To: Kristopher Byrd, Well Construction Section Manager
From: Tommy Laird, Well Construction Program Coordinator
Subject: Review of Water Right Application G-18851
Date: October 19, 2023

Groundwater Application Review Summary Form

Application # G- 18851

TO: Water Rights Section Date 7/28/2023
 FROM: Groundwater Section Grayson Fish
 Reviewer's Name
 SUBJECT: Application G- 18851 Supersedes review of 6/16/2020
 Date of Review(s)

Well Location Map

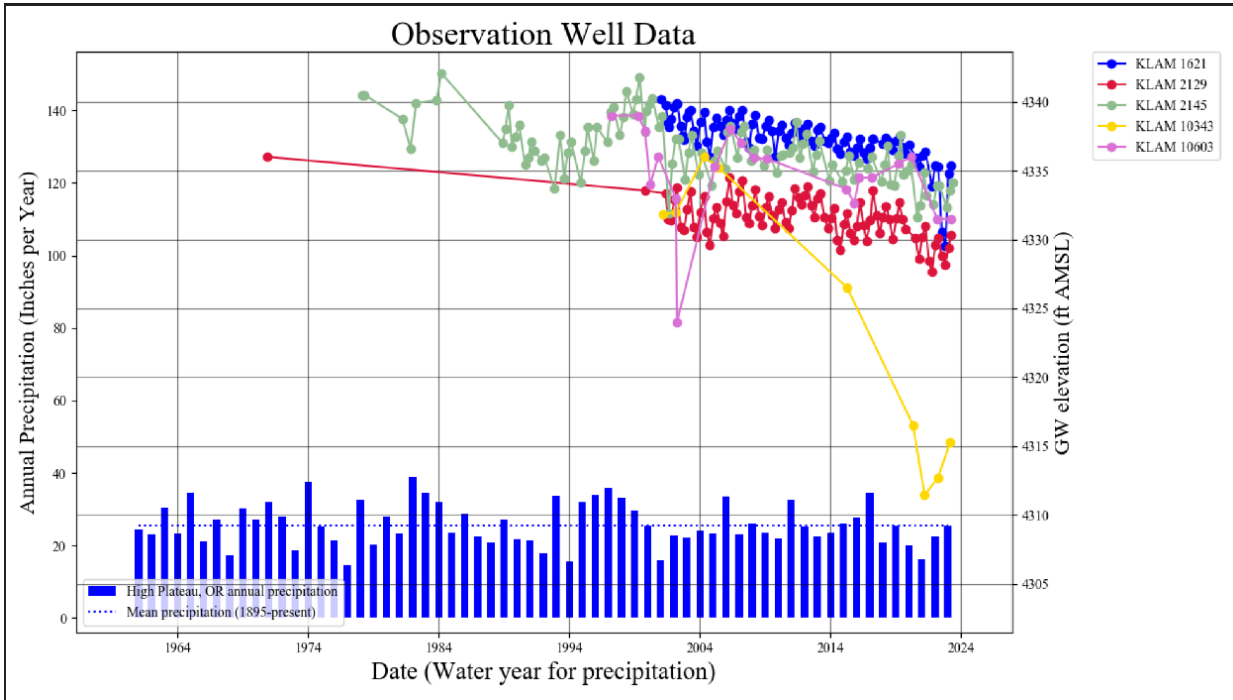
B3. **Groundwater availability remarks:** The applicants proposed wells would develop water from the crystalline volcanic aquifer that underly the Sprague River valley. There are limited water level data in the vicinity of the applicant’s proposed POA. The closest observation wells **KLAM 1621** and **KLAM 10343** are over 3 miles away in the westerly direction; however, these wells extend into the volcanic rock at depths greater than 300 feet below land surface and groundwater elevations are likely be similar to the proposed well. Similarly, observation wells **KLAM 2129**, **KLAM 10603** and **KLAM 2145** are over six miles to the southeast but have similar groundwater elevations (within 5 feet) as **KLAM 1621** and **KLAM 10343**. In general, the hydrographs follow climatic trends with approximately 5 feet of decline over the period of record. The hydrograph of **KLAM 10343** shows similar groundwater elevations as the other wells considered through 2005. However, between 2005 and 2023, groundwater elevation in **KLAM 10343** declined approximately 20 feet. The groundwater declines observed in **KLAM 10343** do appear to be anomalous compared to other wells in this portion of the Sprague River Valley. Available groundwater level data in the noted wells do not display excessive declines or excessively declining trends, therefore there is not a preponderance of evidence that groundwater of the target aquifer is over appropriated. Similarly, there is not a preponderance of evidence that the proposed use would not be within the capacity of the resource and so conditions in B1(d) are recommended.

There are no permitted groundwater rights within 1 miles of the applicants proposed POA and the nearest is 1.2 miles away. At this distance, and given the nature of the aquifer system in the area (high-transmissivity, high-yield), it is unlikely that the applicant’s use would result in injury to these permitted water rights. However, standard interference conditions should be applied.

Stream-Depletion Model Results

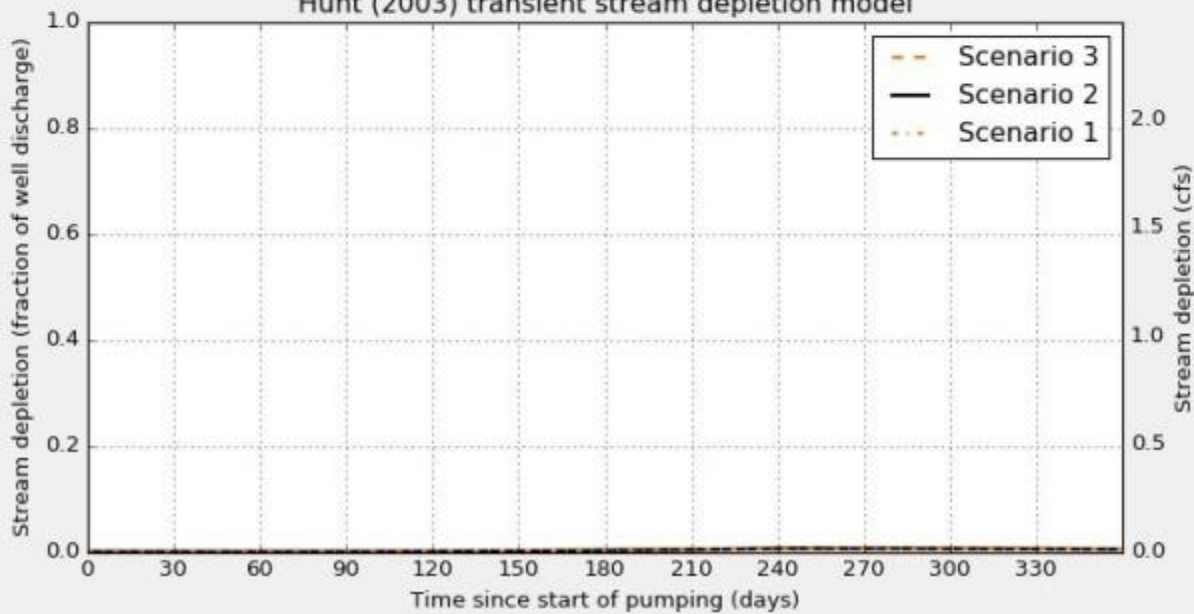
Basis for impact evaluation: Stream-depletion was estimated for each well to Snake Creek (which has the lower WAB flows) using the Hunt (2003) stream-depletion model with parameter values informed by Gannett et al. (2012) and using methods previously used by the Department for estimating stream-depletion in the Klamath Basin. The main control on stream-depletion for this application is the distance to the nearest, hydraulically-connected stream reach, which is based on assumed static water levels and on proposed construction. Stream-depletion estimates are assumed to be different if the well is not constructed as proposed.

C6. **SW / GW Remarks and Conditions:** The applicant's proposed POA would be producing from an aquifer that has been found to be hydraulically connected to surface water – specifically Fivemile Creek and Snake Creek – at distances of over 3 miles. Stream-depletion was estimated using standards practices of the department and the proposed rate and level of impact does not reach the level where PSI is assumed.
